Subject: CHECK ENGINE LIGHT ON WITH P0451:00 IN COLD WEATHER	Bulletin No: 01-003/17
	Last Issued: 01/20/2017

2014-2016 Mazda3 vehicles with VINs starting with JM1

2014-2016 Mazda3 vehicles with VINs starting with 3MZ

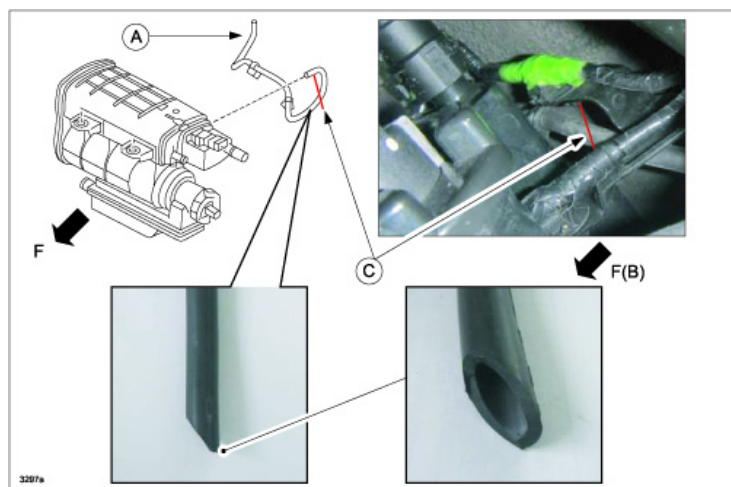
When the engine is started for the first time after parking overnight in cold weather (below freezing), some vehicles may exhibit the check engine light on with DTC P0451:00 (Fuel tank pressure sensor: sensor characteristic malfunction) stored in memory. This concern may be caused by an increase in discharge resistance due to water accumulated and frozen in the canister vent hose.

1. Verify the customer concern
2. Safely lift the vehicle up on a hoist.
3. Check if the Canister Vent Hose is clogged with frozen water.
 - If the hose is clogged with frozen water, go to the next step.
 - If the hose is not clogged with frozen water, refer to MS3 online instructions to diagnose DTC P0451:00.
4. For 4-door sedan
 - a. Cut the Evaporative Hose No.1 (A) diagonally to enlarge the cross section as shown (C = cut point) to avoid water from accumulating and freezing. (F = vehicle front, F(B) = Vehicle front (view from bottom))

For 5-door hatchback

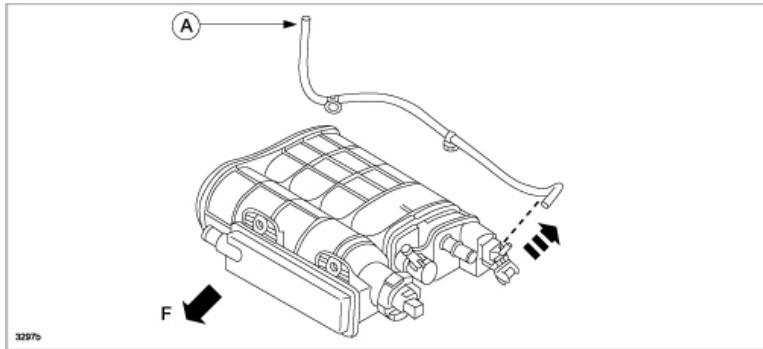
- a. Pull out the Evaporative Hose No.1 (A) from the Charcoal Canister outlet.

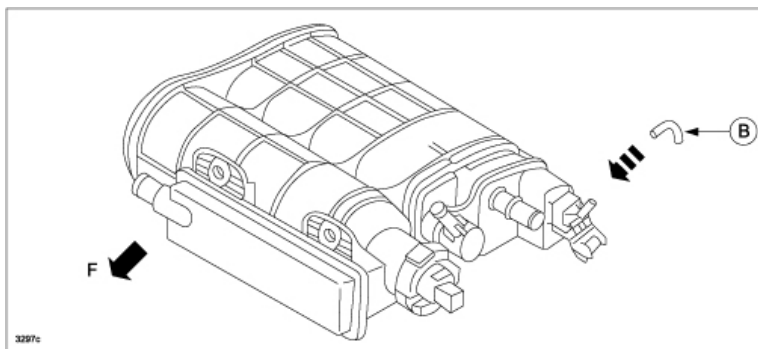
- b. Install the Canister Hose (PE01-13-971) (B) to the Charcoal Canister outlet.

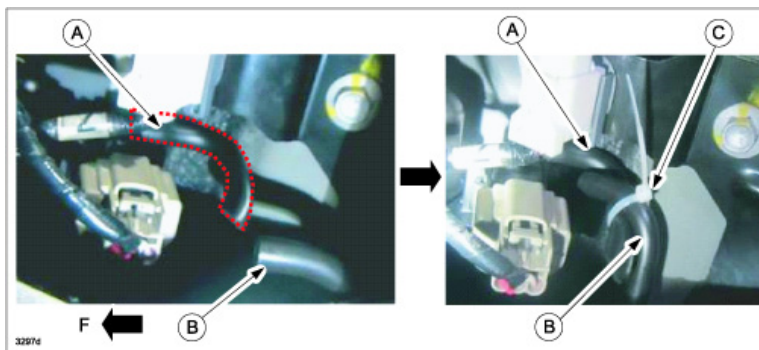
- c. Tie the Evaporative Hose No.1 (A) and the Canister Hose (PE01-13-971) (B) with a tie-wrap (C) as shown.
